SUBJECT: Entergy Nuclear Operations, Inc.
Pilgrim Nuclear Power Station
Docket No. 50-293
License No. DPR-35

Revised Pilgrim Relief Request (PRR)-21, Contingency Repair Plan for Reactor Pressure Vessel (RPV) Standby Liquid Control Nozzle Weld, RPV-N14-1.

Pilgrim Relief Request (PRR)-19, Jet Pump Instrumentation Nozzle Weld,
RPV-N9A-1 Repair Plan

**PILGRIM RELIEF REQUEST (PRR)-19,
JET PUMP INSTRUMENTATION NOZZLE WELD, RPV-N9A-1, REPAIR PLAN**

RPV-N14-1 WELD OVERLAY CONFIGURATION

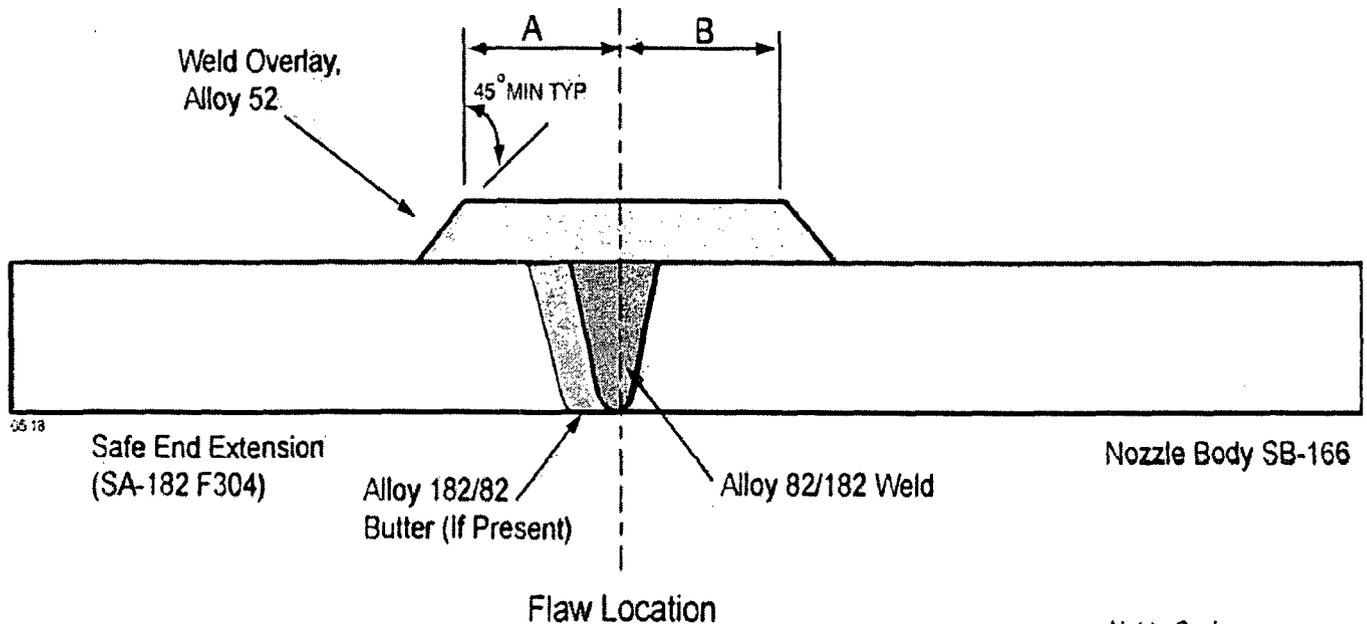
Standby Liquid Control nozzle safe end-to-nozzle weld RPV-N14-1 is a 2.5 inch OD butt weld consisting of an Alloy 600 nozzle assembly welded to a 304 stainless steel safe end extension with Inconel 182 filler metal (ref. BWRVIP-27A Figure 2-1). Since this weld is less than 4 inches in diameter, the 1998 edition with 2000 addenda of the ASME Section XI code requires a surface examination every ten years. Pilgrim received approval to implement a Class 1 risk-informed inspection program in 2001 in lieu of ASME Section XI requirements. This weld is not included in the risk-informed program inspection sample but has been examined periodically with surface and visual examination methods and will be examined using ultrasonic methods during RFO18 and every ten years thereafter in accordance with BWRVIP-27A requirements.

Figure 1 Existing N9A Weld Configuration (1984 Repair)

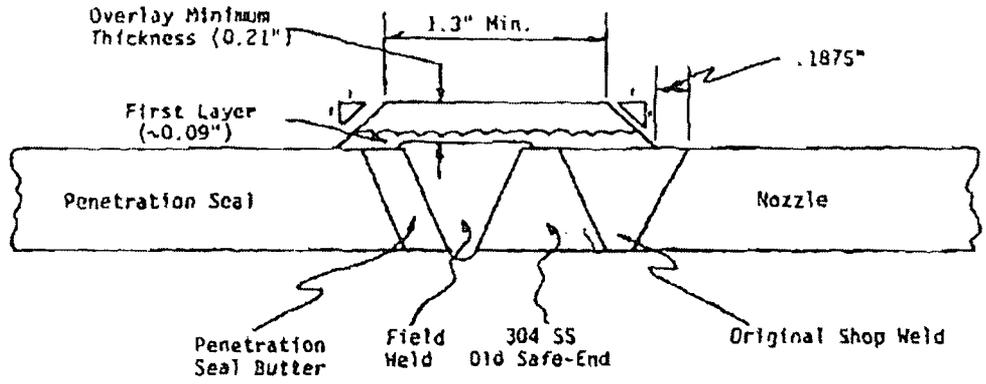
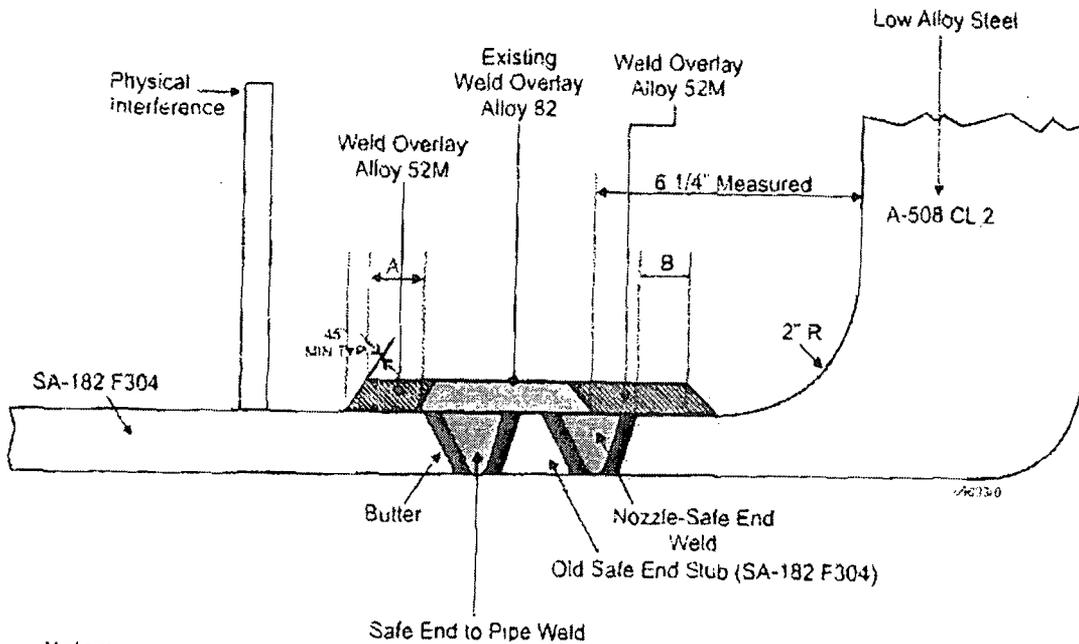
Supplement 11 as implemented by the Performance Demonstration Initiative (PDI). However, prior to performing the UT examination, PNPS determined that the subject WOL could not be appropriately examined due to its present configuration. See Table 1 and Figure 1 of Attachment 1 for additional details on the existing WOL configuration and materials. The Inservice Inspection (ISI) weld number for the subject WOL is RPV-N9A-1.

Entergy has initiated this request to propose an alternative to the ASME Section XI Code. PNPS intends to use Code Cases N-504-3 and N-638-1 to modify the existing WOL of the Jet Pump Instrumentation Nozzle N-9A (ISI weld RPV-9A-1). The modification will be performed using Alloy 52M (ERNiCrFe-7A) filler metal to facilitate performance of the required Appendix VIII, Supplement 11 UT examination. See Figure 2 of Attachment 1 for additional details.

4. Code Case N-504-3, paragraph (f)(1) and Appendix Q, paragraph Q-3000(b)(2) require that the end transition slope of the WOL "not exceed 45°". As an alternative, Entergy proposes to allow the end transition slope to exceed 45° provide the following two conditions are met:

- A physical restriction along the Jet Pump Instrument Penetration Seal Assembly prevents the WOL end transition slope from being 45° or less.
 - The as-built configuration of the WOL is analyzed by Finite Element Analysis to demonstrate compliance with the applicable stress limits of the Construction Code.

- 3.7.4 The fourth proposed modification is to Code Case N-504-3, paragraph (f)(1) and ASME Code, Section XI, Appendix Q, Subparagraph Q-3000(b)(2) which require that the end transition slope of the WOL "not exceed 45°." The licensee intends to comply with this requirement. However, the primary purpose of this weld overlay is to make the weld configuration able to be UT inspected, but due to the geometry of the configuration of the weldment and interferences from other equipment the licensee may not be able to comply with this requirement. The licensee will demonstrate compliance with the applicable stress limits of the Construction Code or ASME Code, Section III on this weld configuration. Therefore, since the weld configuration will meet the applicable stress limits of the original Construction Code or ASME Code, Section III, the NRC staff finds that the requested alternative will provide an acceptable level of quality and safety
